FROM : PARKER MEGGITT TECHNICAL PUBLICATIONS

REVISION 002  
dated Sep 12/23

## SB 25-1111432

#### Information Regarding the Potential Failure of the Guarded Rotary Buckles with Plastic Handles PNR 1111430-XX and PNR 1111475-XX

**Figure 5**  
*Optional Inspection Tool PNR 1111432-GA*

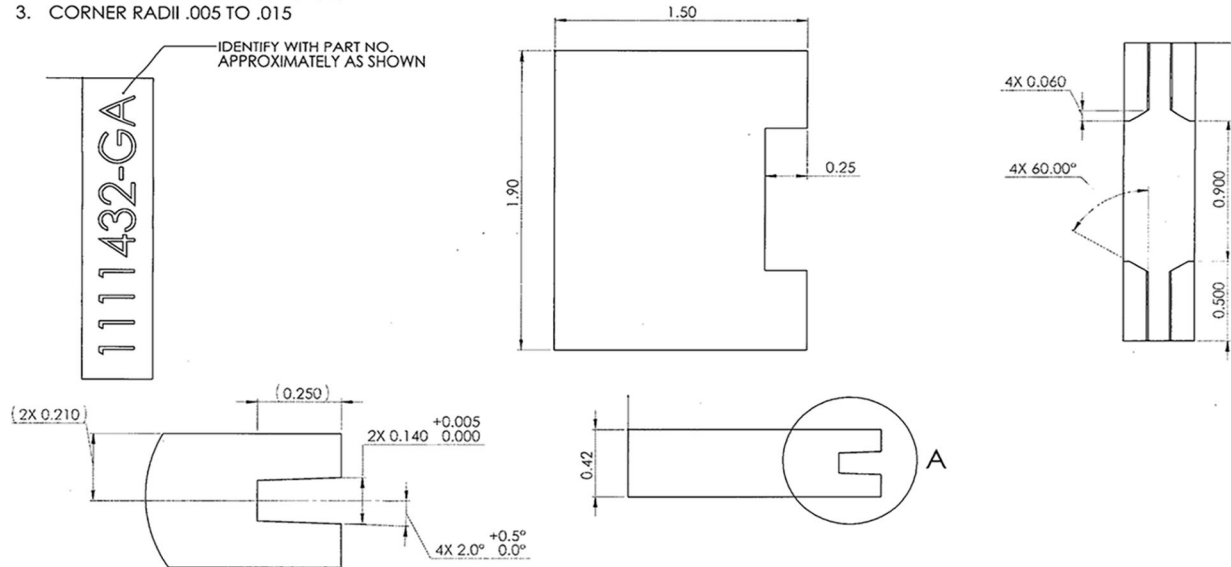
- (1) Measure the handles in accordance with Figure 3 on page 20 and Figure 4 on page 20 to make sure the handles are less than 0.125 inches at the top edge. Parker Meggitt has created an optional inspection tool (PNR 1111432-GA). Contact Parker Meggitt for purchase of the inspection tool. Refer to Figure 5 on page 21 for correct use of the optional inspection tool.

## OPTIONAL INSPECTION TOOL FITS OVER VANES CENTER IS FLUSH TO BUTTON

1. MATERIAL: NYLON, DELRIN, ASA, OR OTHER SIMILAR 3D PRINTED MATERIAL
2. BREAK SHARP EDGES .005 TO .015
3. CORNER RADII .005 TO .015

NOTE 2 : If using an inspection tool, make sure the tool fits over the vanes and the center is flushed to the button.

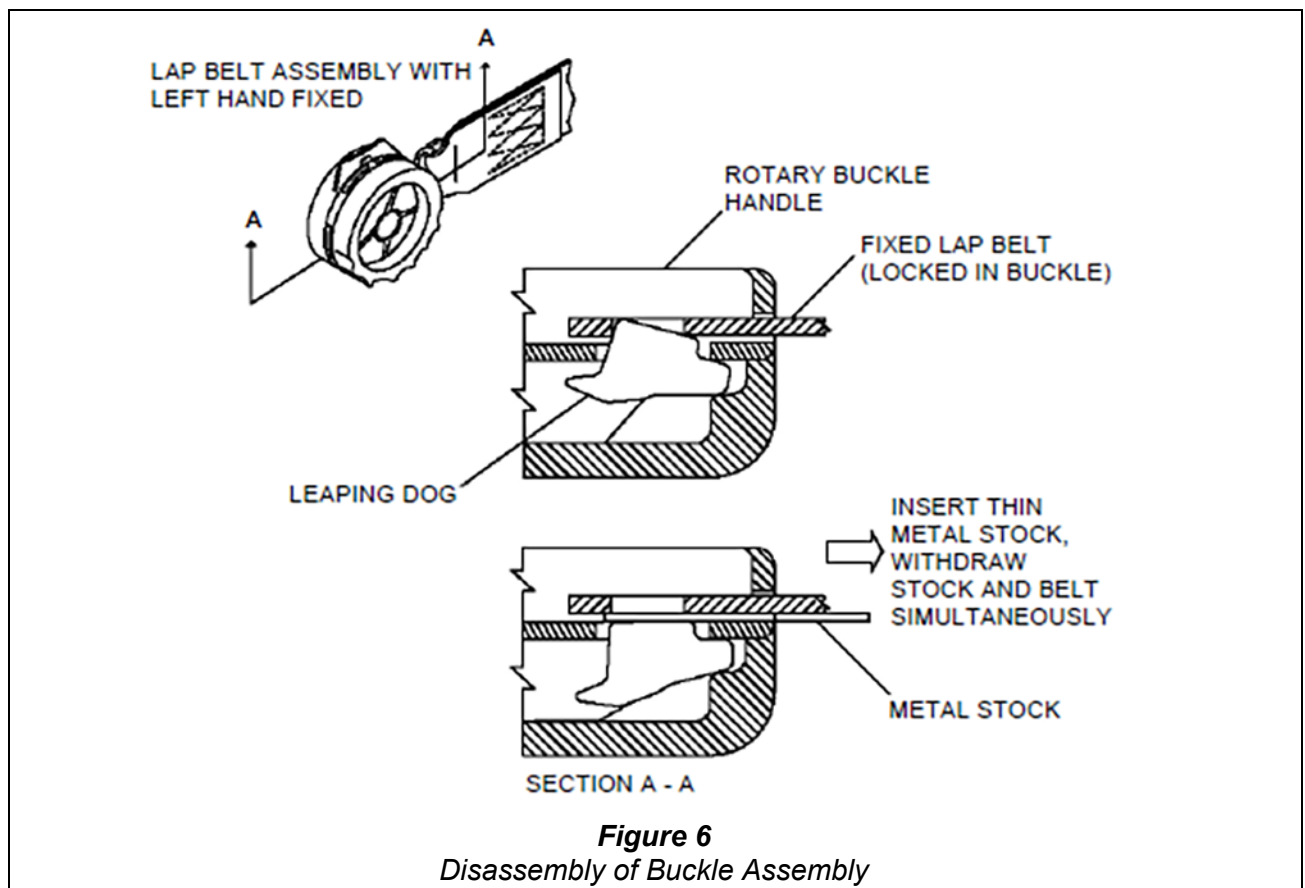
- (1) Remove and replace the restraint system with a spare.
- (2) Refer to the paragraph 4.D. and 4.E. for disassembly and assembly of restraint system to repair the removed restraint system :
  - (a) Remove the buckle assembly in accordance with Figure 6 on page 23.
  - (b) Replace the suspect buckle assembly with a new and compliant unit.

- (1) Insert a piece of thin metal stock into the slot of the rotary buckle and push inward between the fitting and the buckle locking mechanism (refer to Figure 6).
- (2) Pull the fitting from the buckle.
- (3) Remove the buckle pad as necessary.
